**Re: Flatiron Meadows Planning Area C Preliminary Plat, Amendment No. 2
Comment Response Letter**

**FLATIRON MEADOWS – PLANNING AREA C
PRELIMINARY PLAT REVIEW RESPONSE**

FLATIRON MEADOWS PRELIMINARY PLAT, AMENDMENT NO. 2

FLATIRON MEADOWS
 PRELIMINARY PLAT
OVERALL UTILITY PLAN

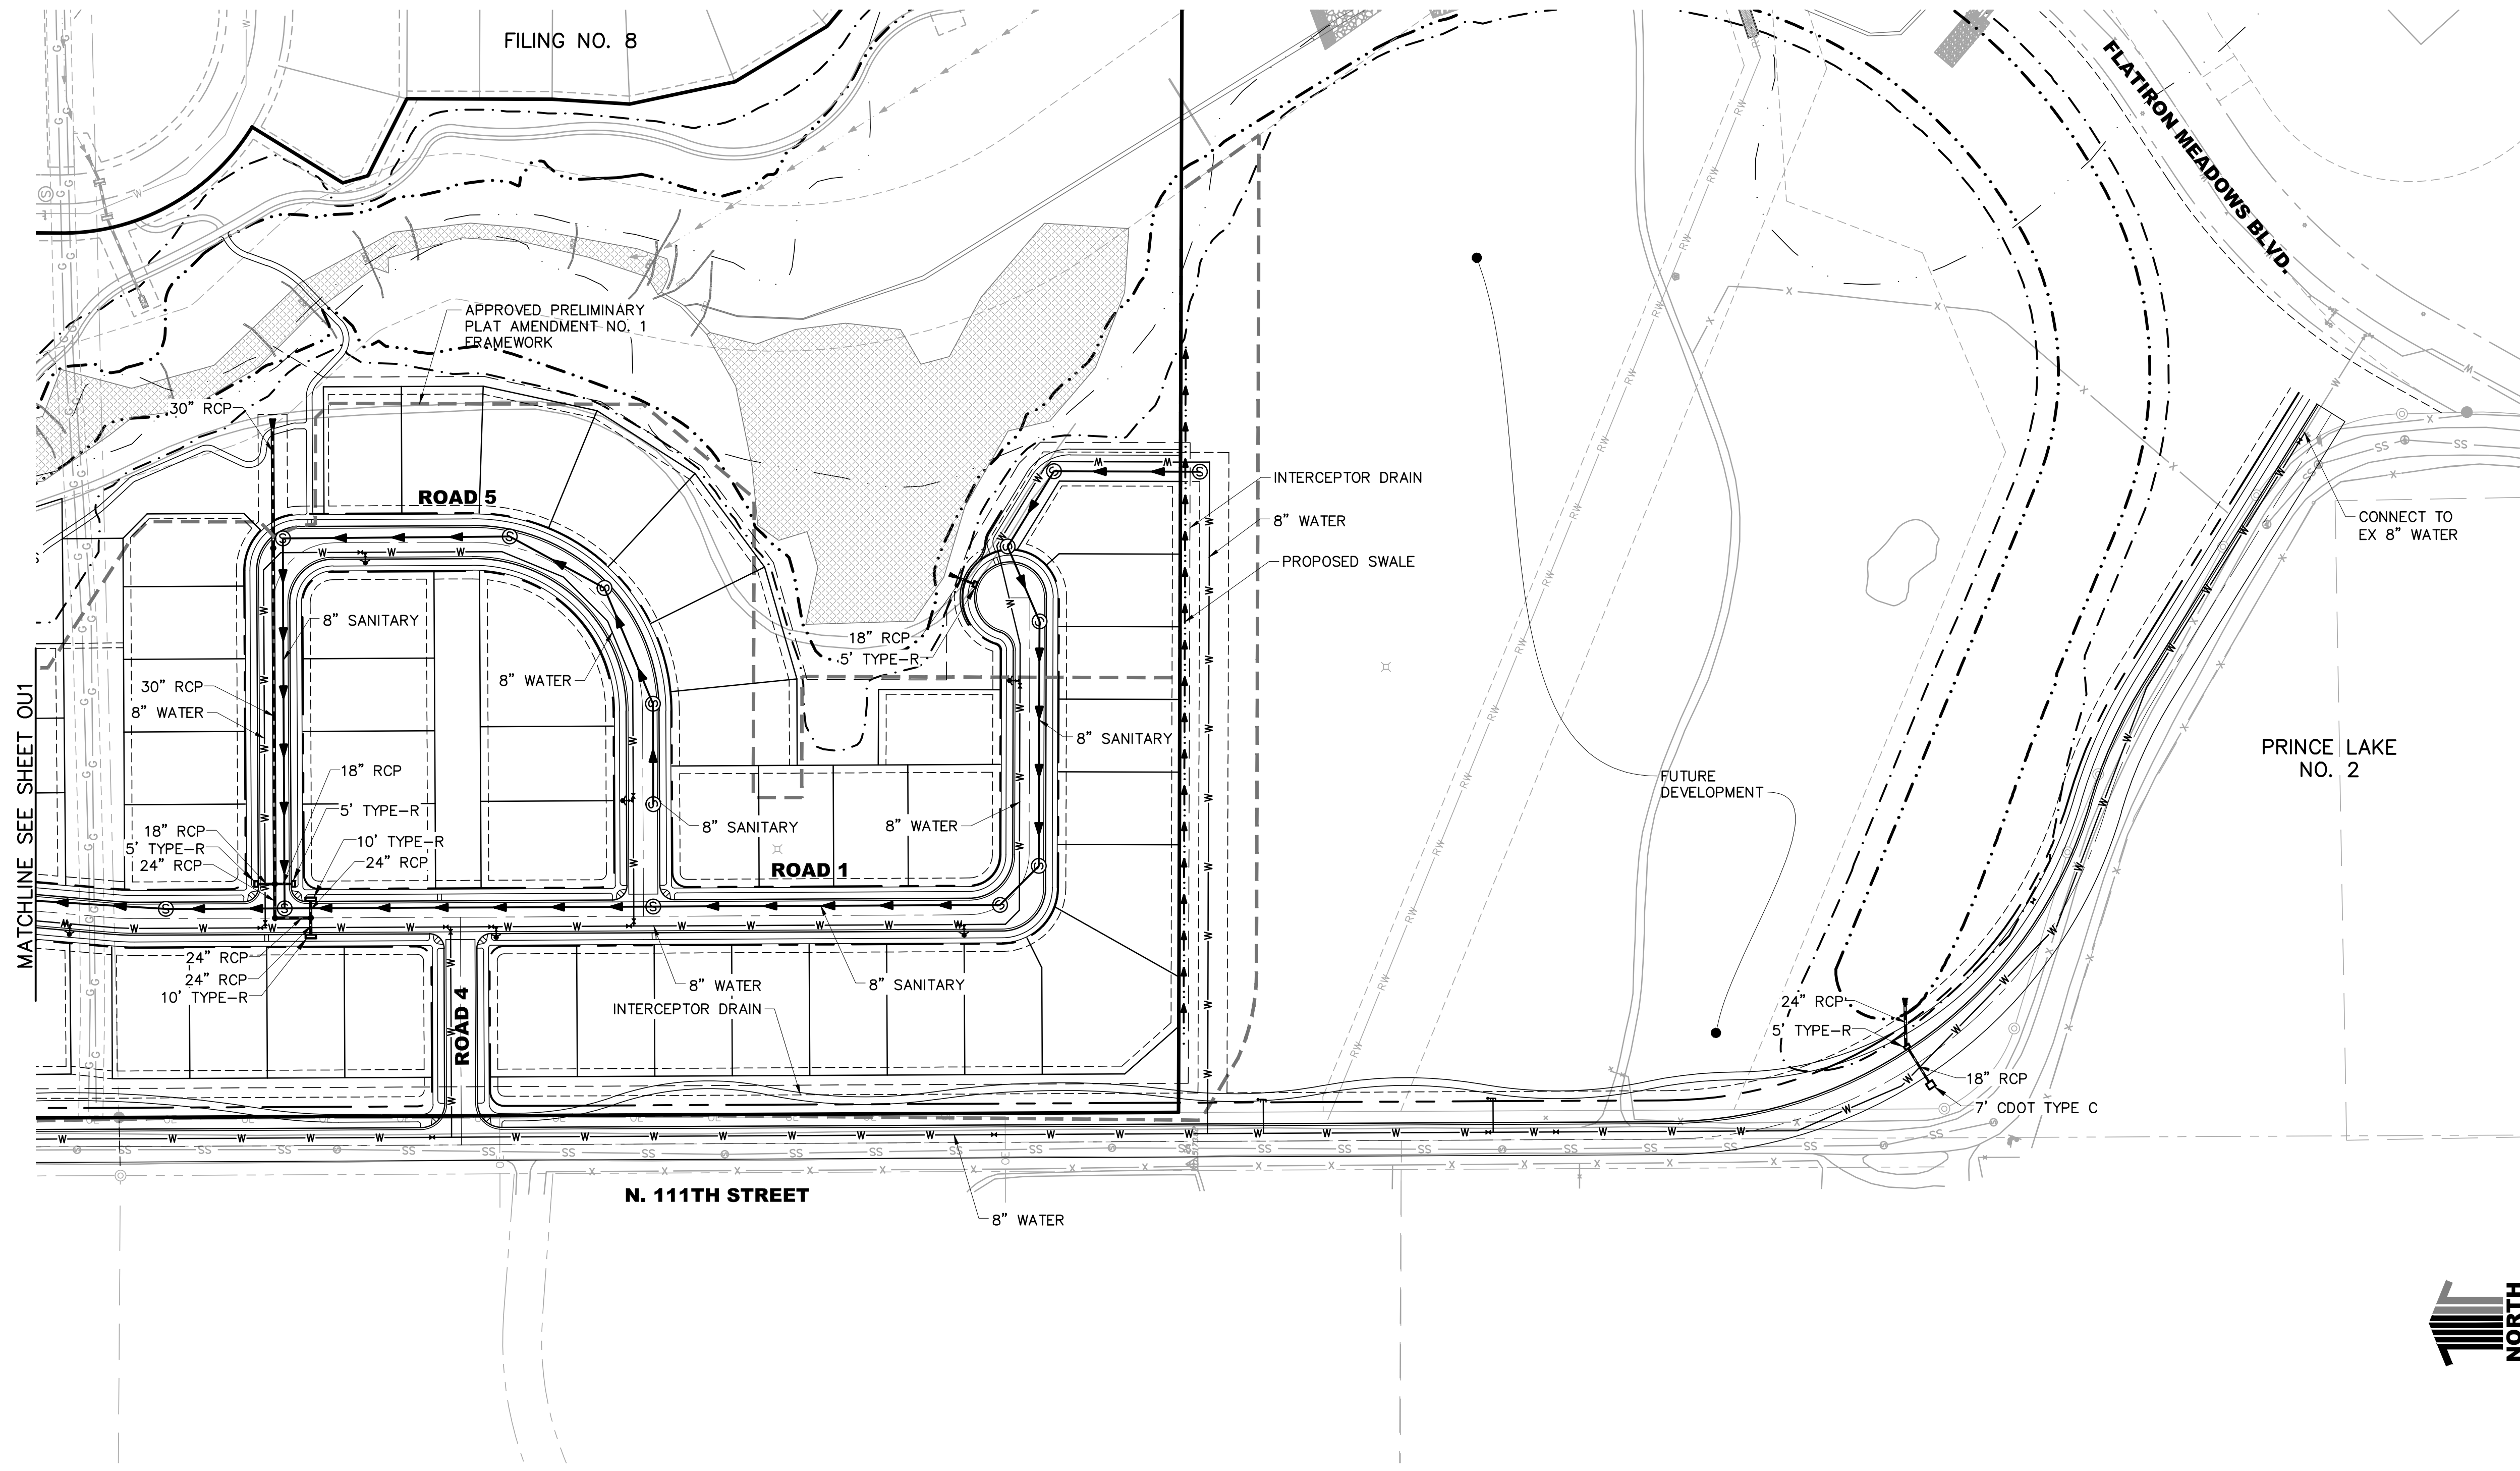
Response: The sewer line is now in a 30' wide easement.
 - c. This same easement is partially located in the wetlands. Relocate easement outside of wetlands.

Response: The easement has been shifted west with the lot shift to obtain more clearance from the wetlands.
7. Sheets GR1 and GR2 – Grading Plans
 - a. *Note: Town comments were revised to reflected the revised grading plan submitted on January 10, 2017.* There is proposed fill in the 10' range on the north side of the subdivision and at the Road 5 bulb adjacent to open space. Naturalize any proposed grading along the open space corridor.

FLATIRON MEADOWS
 PRELIMINARY PLAT
 GRADING PLAN

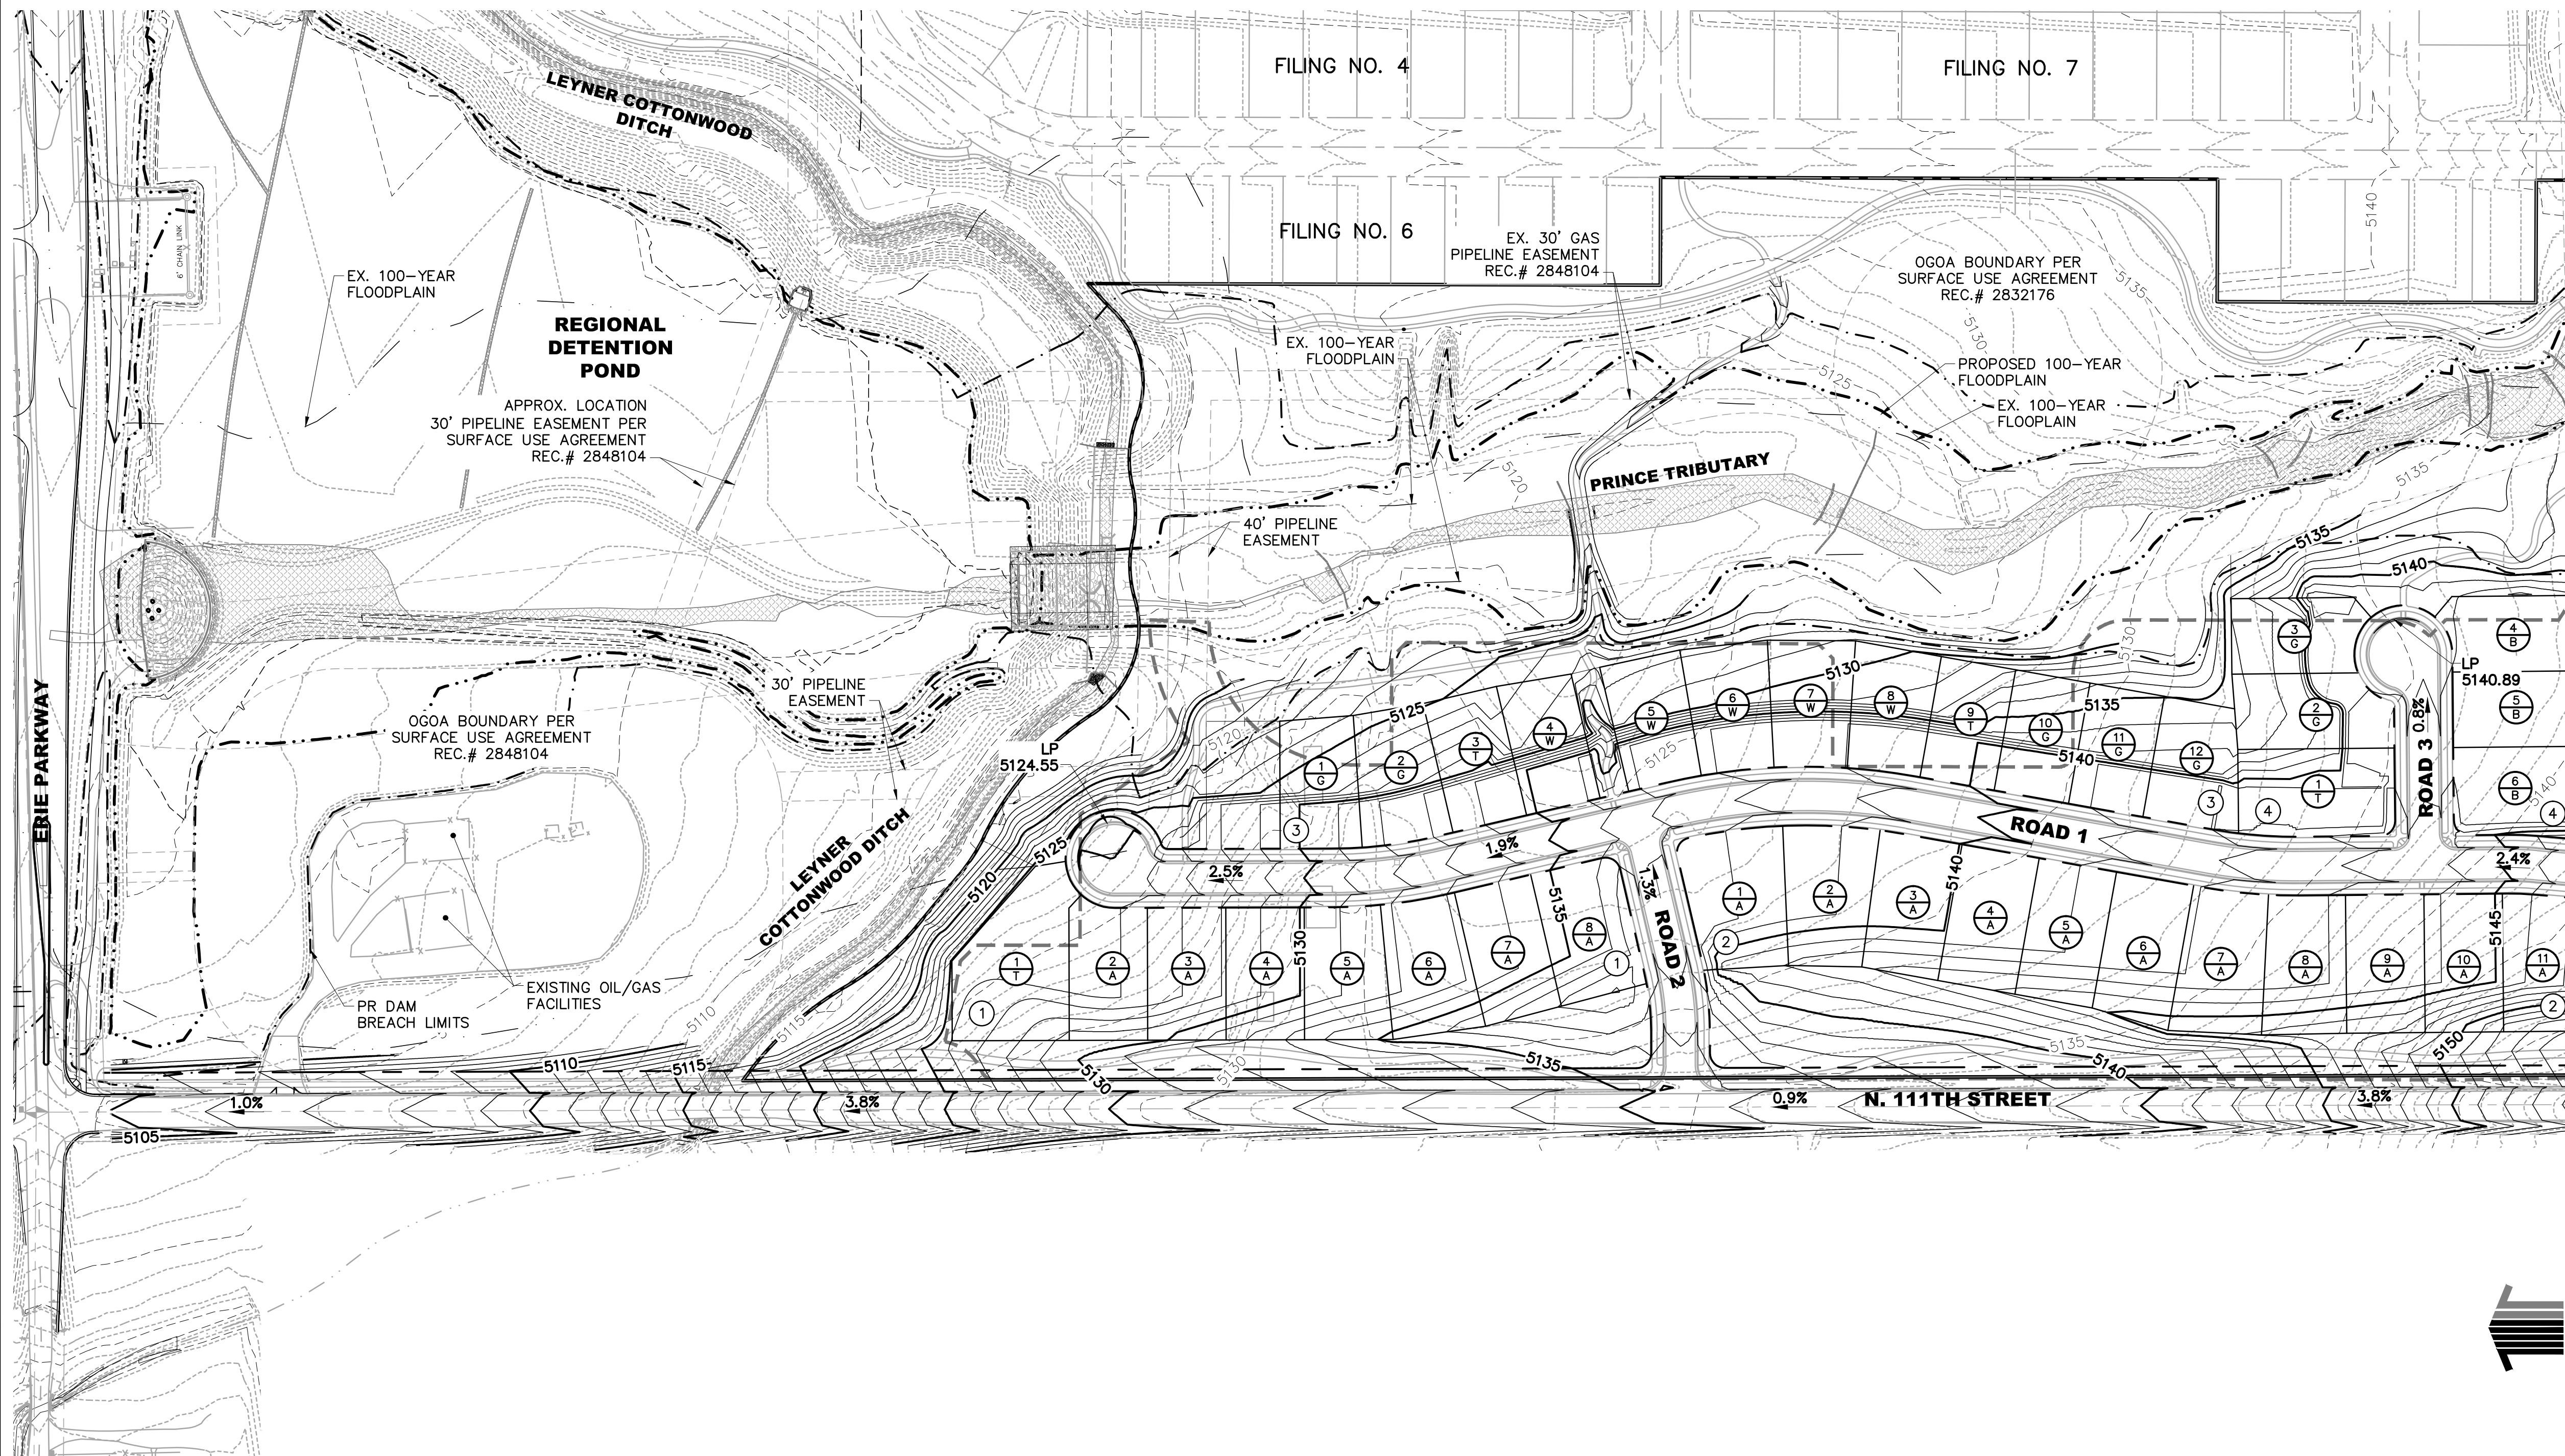
Response: Grades have been naturalized in the open space and do not exceed 5:1 slopes.
 - b. At Block 8, Lots 1-5, the adjacent Dam Breach elevation is the 45' contour which appears to go into the rear of lots. Adjustments may be needed to push the dam breach/grading outs of affected lots.

Response: The dam breach elevations change with the channel. The elevations shown at the section line are static and do not reflect the elevation at all points of a lot. The Dam Breach water surface has been modeled and compared to the final grading plan. We have verified that all points of the lot are above the Dam Breach water surface.
